1 FLOOR PLAN
1/4" = 1'-0"

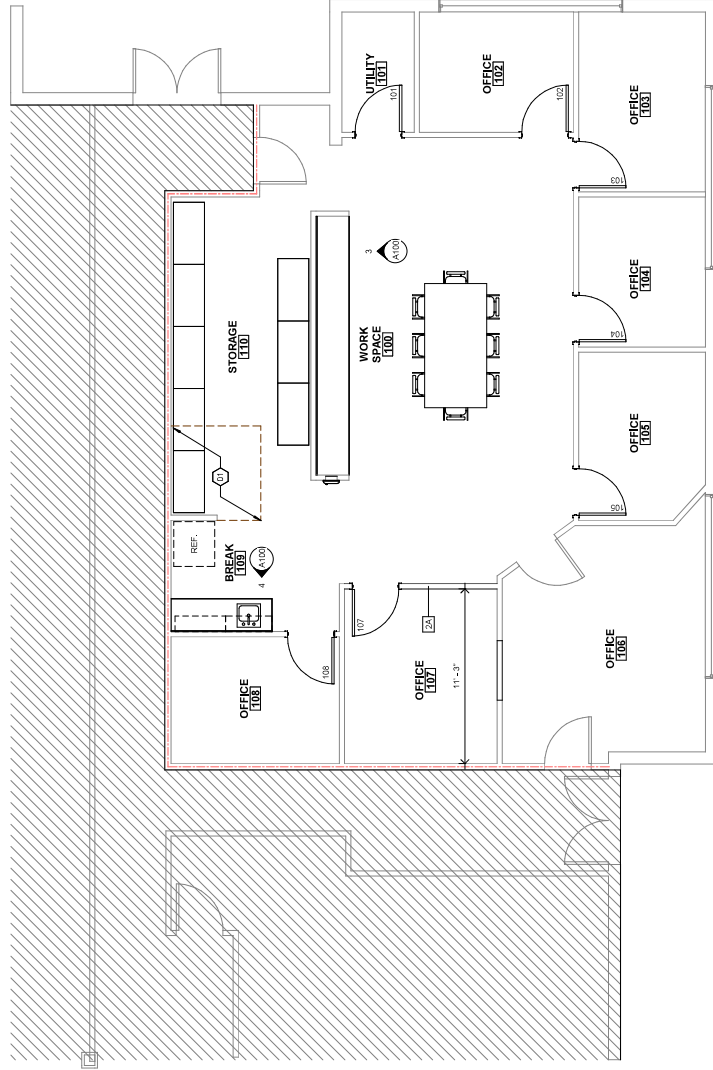
**CAN YOU INCREASE WIDTH OF DRAWER
STACK SO THAT MAX DOOR SIZE IS 1'-6" WIDE.
I AM CONCERNED ABOUT CLEARANCE WITH
THE REFRIGERATOR**
